Application Assessment Panel

Tuesday 8 October 2024
3.00pm

CONSIDERATION OF REVIEW

Image 1 (left) & 2 (right). Refused and amended Basement Plan. Source: Refused and Amended Architectural Plans

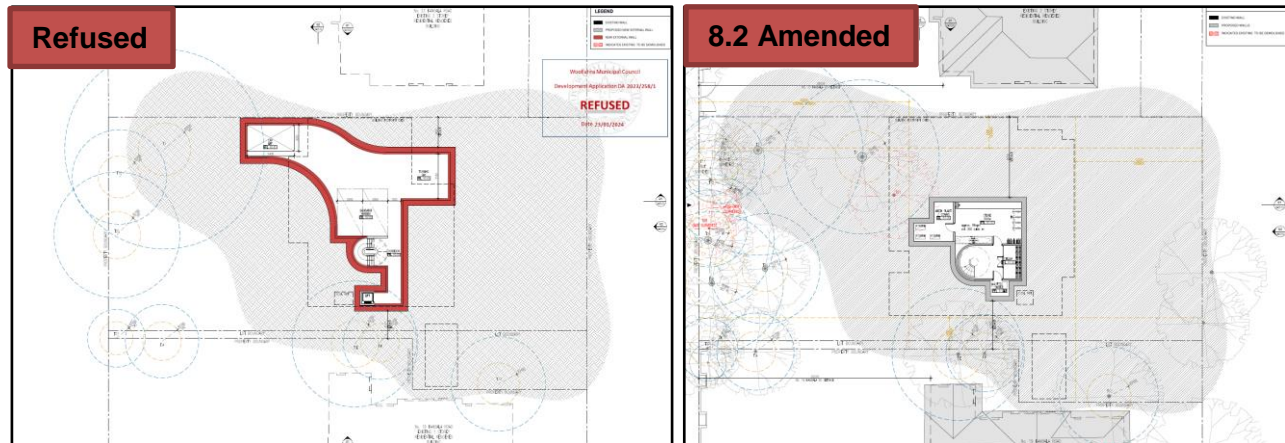
- Excavation to accommodate a new basement level within the existing building footprint, including: mechanical plant/comms room; storeroom; stairs; cellar; and hot water plant room.

Image 3 (left) & 4 (right). Refused and amended Ground Floor Plan. Source: Refused and Amended Architectural Plans

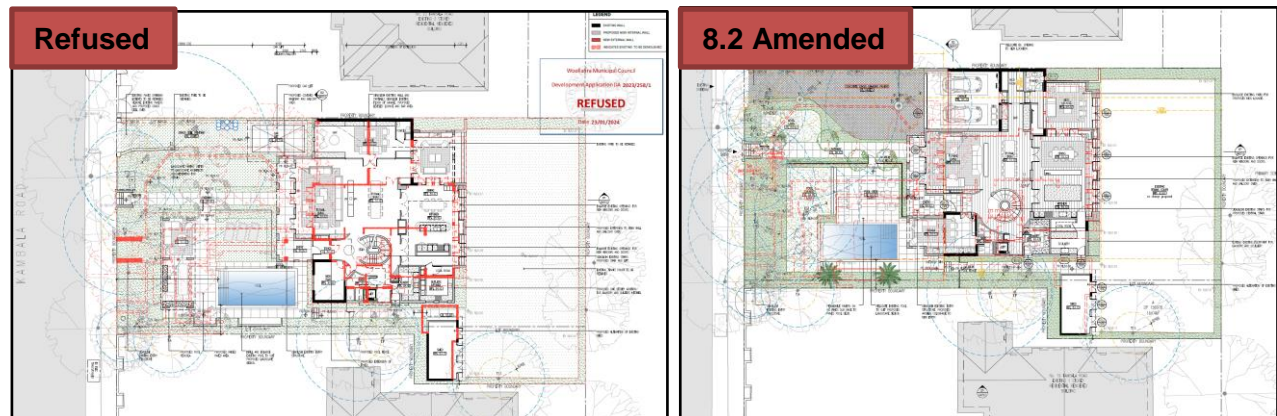
- Substantial demolition of the existing ground floor level, swimming pool and associated landscape structures to accommodate alterations and additions, including: new landscaping, front boundary portico, retain and refurbish existing front fence and a swimming pool within the front setback area; extension to the existing garage structure; reconfiguration of the internal Ground Floor layout; extension of the existing western (front) elevation resulting in a reduced front setback; and changes to the existing fenestration pattern.

Image 5 (left) & 6 (right). Refused and amended Level 1 Plan. Source: Refused and Amended Architectural Plans

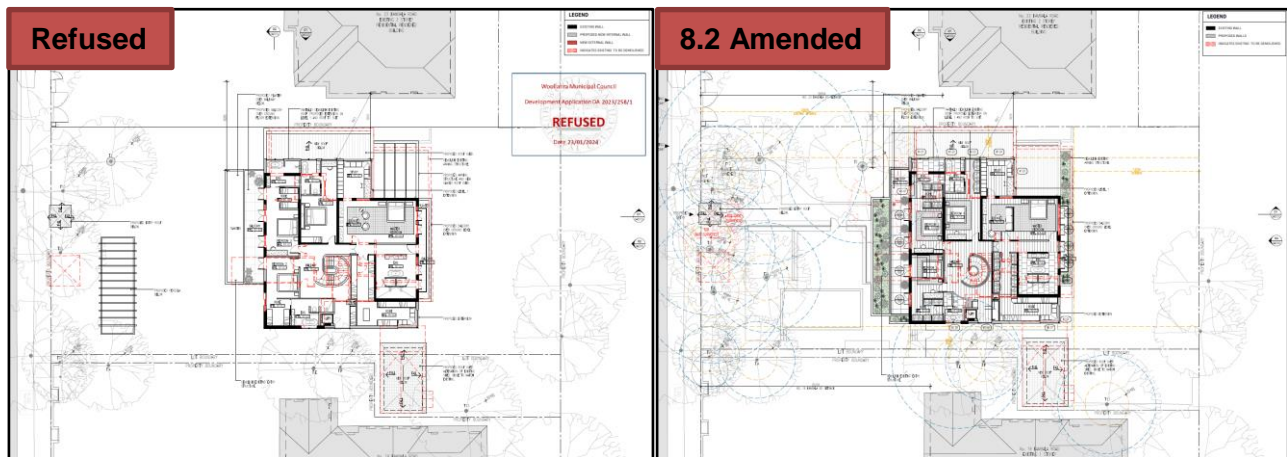
- Demolition of internal and external walls and openings to accommodate alterations and additions, including: proposed internal reconfiguration; and extension of the northern, southern and western elevations to provide additional gross floor area (GFA), Level 1 balcony and associated planter.

Image 7 (left) & 8 (right). Refused and amended Roof Plan. Source: Refused and Amended Architectural Plans

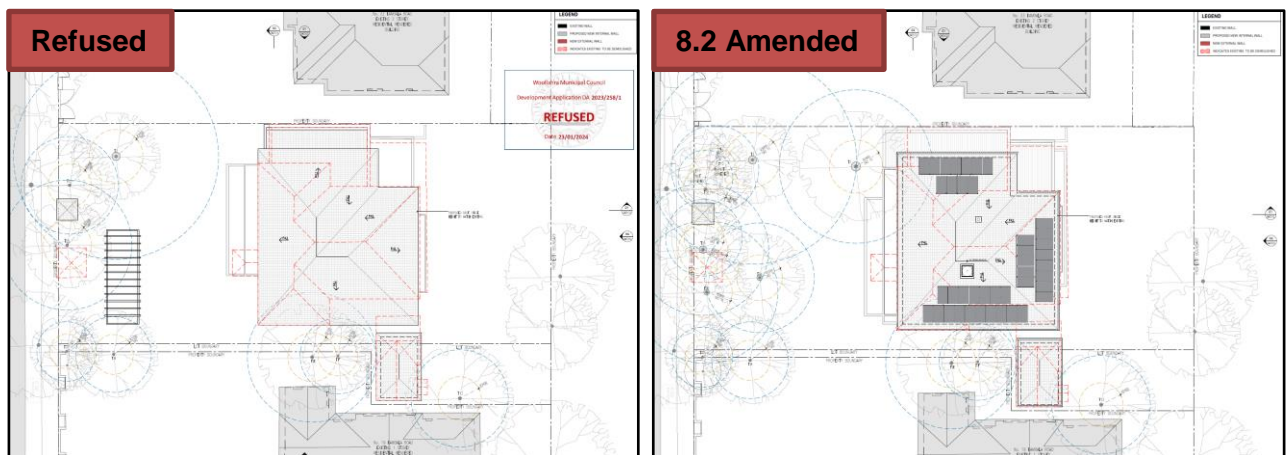
- Demolition of the existing roof structures associated with the existing dwelling and the detached outbuilding, to accommodate new roof structures, including: new tiles to match the existing roof tiles; simplified cross hipped roof design; one (1) skylight; and solar panels.

Figures 3 & 4. Original and amended basement/excavation plans. *Source:* Submitted Architectural Plan

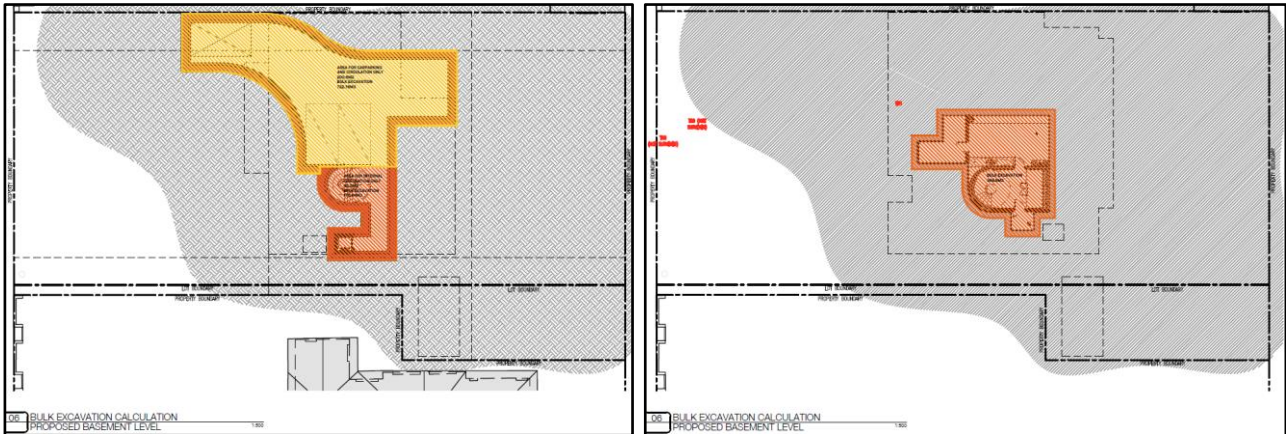
The Proposal results in a minor non-compliance with the second part of C1, being the inclined plane, but is limited to eaves and a portion of the existing front roof plane.

Figure 5. 9m sightlines from northern and southern ends of proposed front balcony. *Source:* Submitted Architectural Plans. *Annotated:* WMC

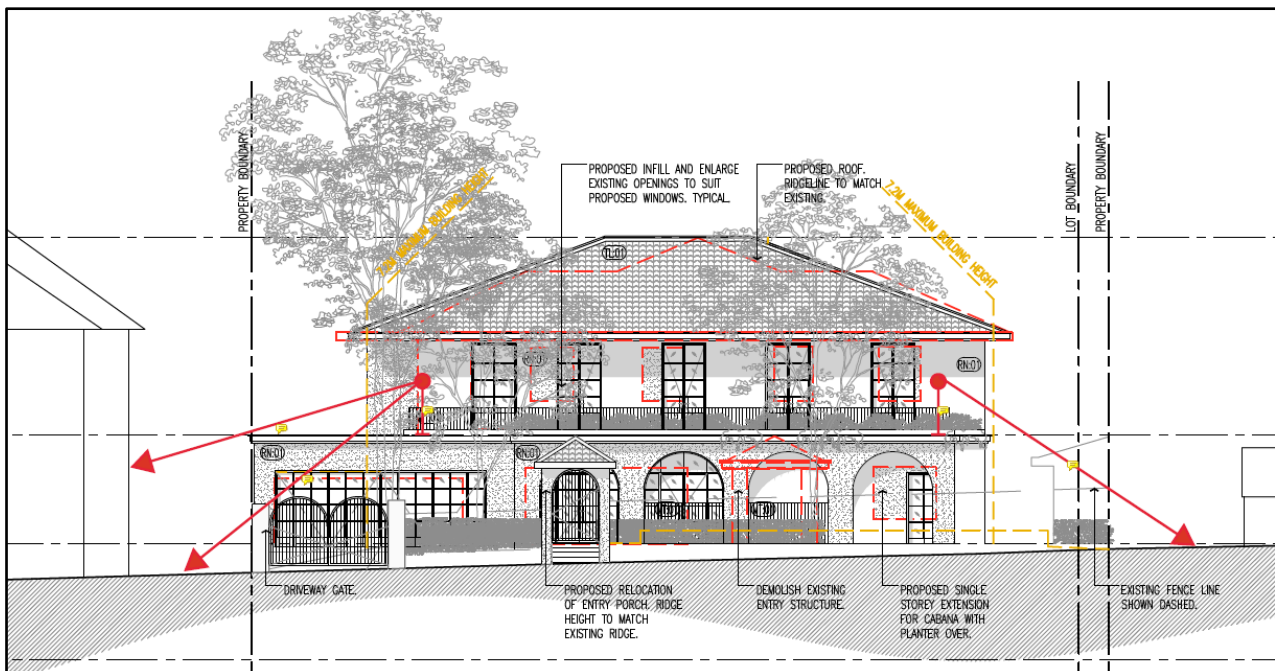
- All Level 1 northern elevation windows are proposed to include obscure glazing. Refer to drawing DA0500 of the submitted Architectural Plans.
- South facing habitable room windows are sited to avoid direct sightlines within 9m to adjoining habitable rooms at 19 Kambala Road.

- vii. Similarly, the intervening southern boundary fence would likely obstruct any sightlines within 9m into the adjoining private open space to the south.

Figure 7. Existing, proposed & amended deep soil landscaped areas. *Source:* Amended Landscape Plans Rev 05

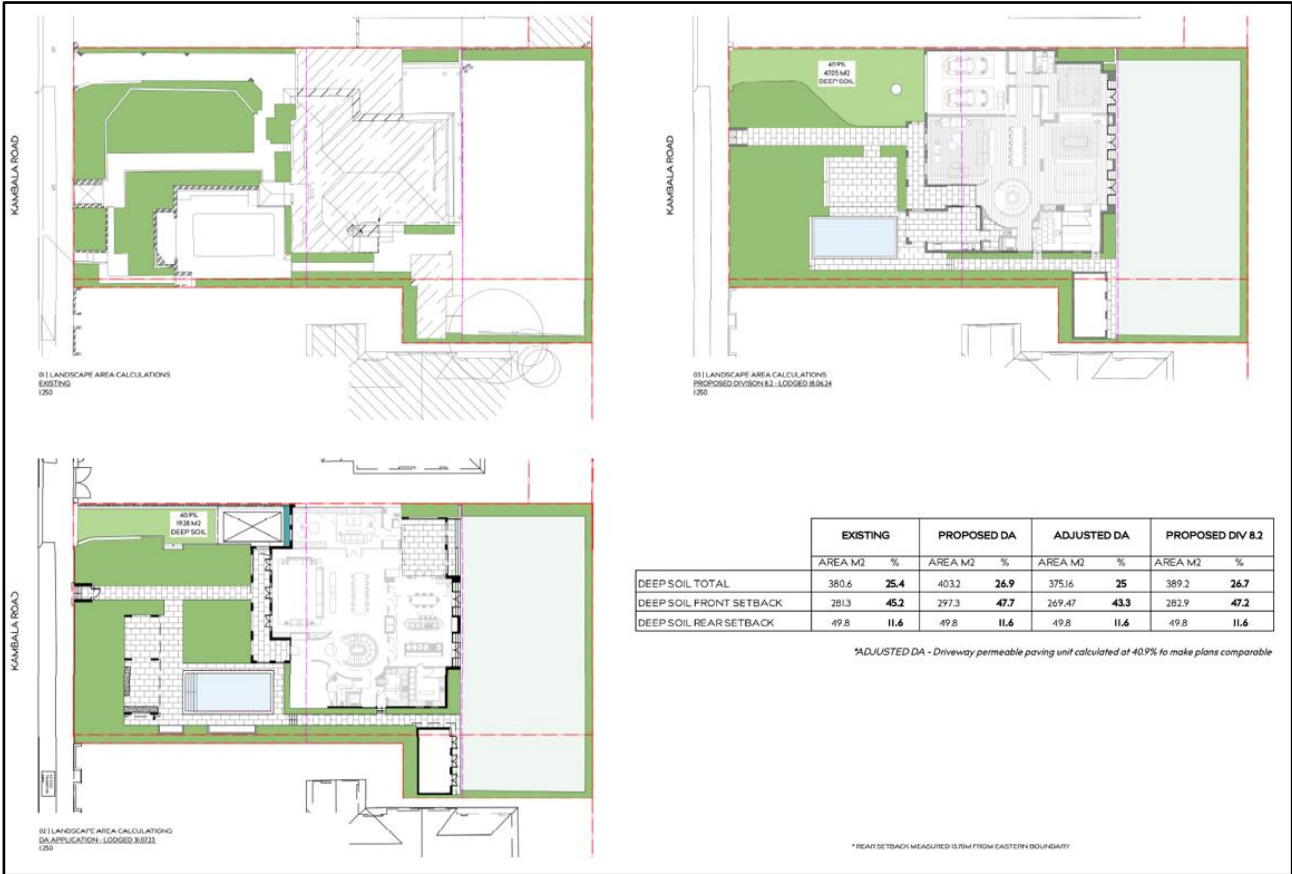
Furthermore, the Amended Plans and Landscape Plans demonstrate no reduction to the existing non-compliant deep soil landscaped area throughout the Site, and compliance with C3. Refer to Figure 7 below.

It is noted that 40.9% of the proposed driveway area is included in the calculation of the proposed deep soil landscaped area. This is achieved by bay of “concrete grass diamond pavers” (Figure 8), which allow portions of the driveway to omit any structure above or below ground level (existing) and capable of growing grass.

Section of Subject site indicating compliant incline wall plane (Source Richards Stanisch)

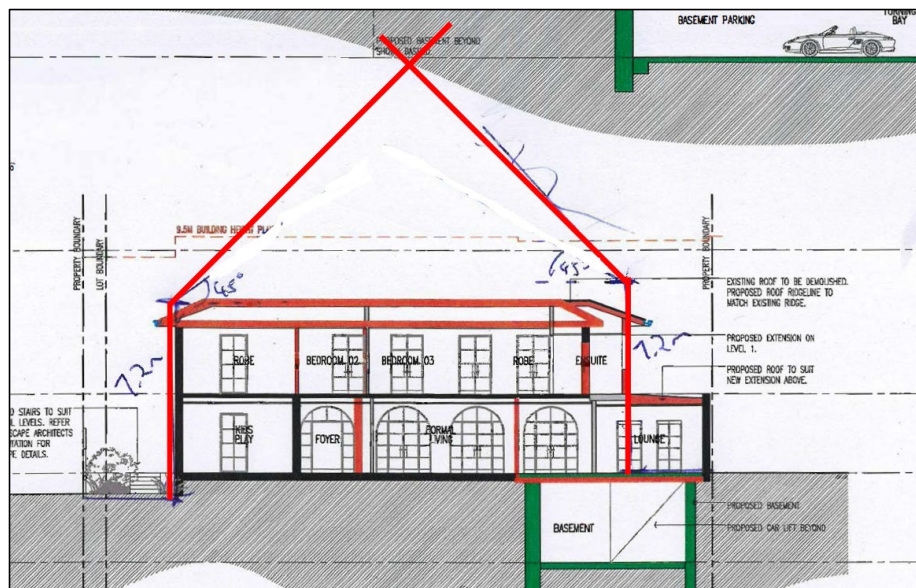
C1 specifies a maximum external wall height of 7.2m with an inclined plane of 45 degrees above this height. Roof eaves can protrude into the setback if they are below the inclined plane; therefore in this case, the minor eave protrusion is acceptable.

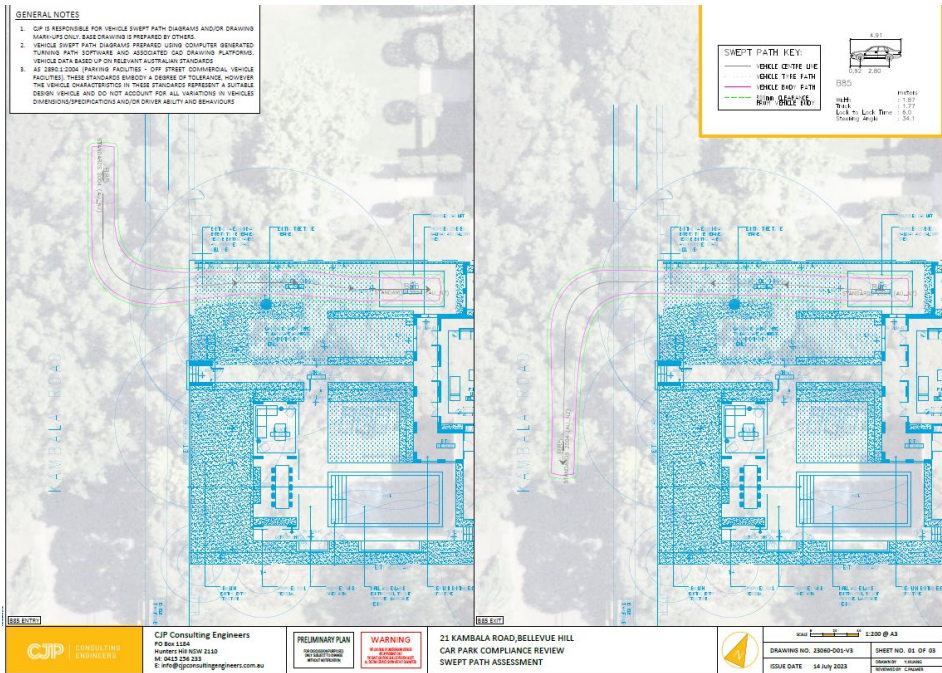
Acceptable on Merit – the proposed earthworks for the new basement carpark will result in a 548.2m³ or approximately 150% breach of Control C1 which limits the subject site to have a maximum of only 350 m³ of excavation and is proposed to occur within the 3.4m side setback Control (C6). Notwithstanding these numerical non-compliances, the proposal is considered acceptable for the following reasons.

- The proposed excavation will maintain the buildings design and does not adversely affect the existing topography of the site.
- The applicant has provided a Geotechnical report which Council's Development Engineer has considered satisfactory and ensures that there are no structural risks to surrounding structures. Noise, vibration, dust and other amenity impacts will also be monitored to reasonable levels as per the provided Structural Report prepared by Structure Engineering project No. 22S0341 dated 06/09/2023 (Objective O1b, O1c and O1d)

Shadow diagrams of existing and proposed works, additional overshadowing in blue (Source: Richards Stanisich)

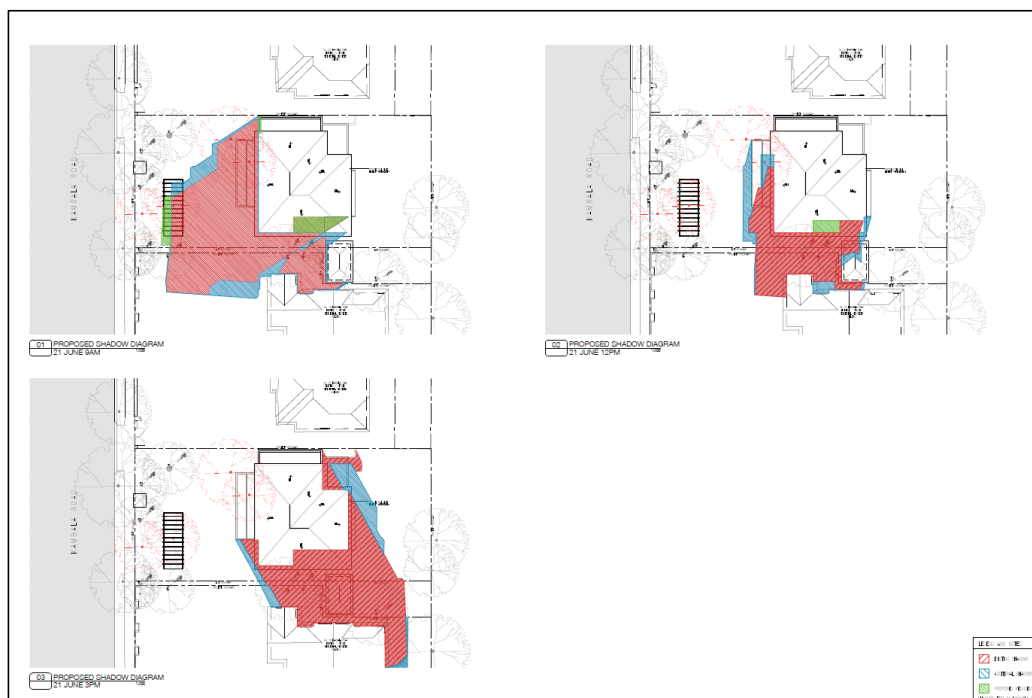
If the application was not being refused, the proposal would have resulted in an improved visual and street quality. The additions improve the architectural design of the existing building by introducing front and rear articulation and maintains a well-designed, consistent as existing, contemporary building and roof form. (C5, C10, O2, O4 and O5). Furthermore, with regards to the front streetscape, the proposal seeks to relocate and reduce the bulk of the existing front entry feature for improved design and accessibility.
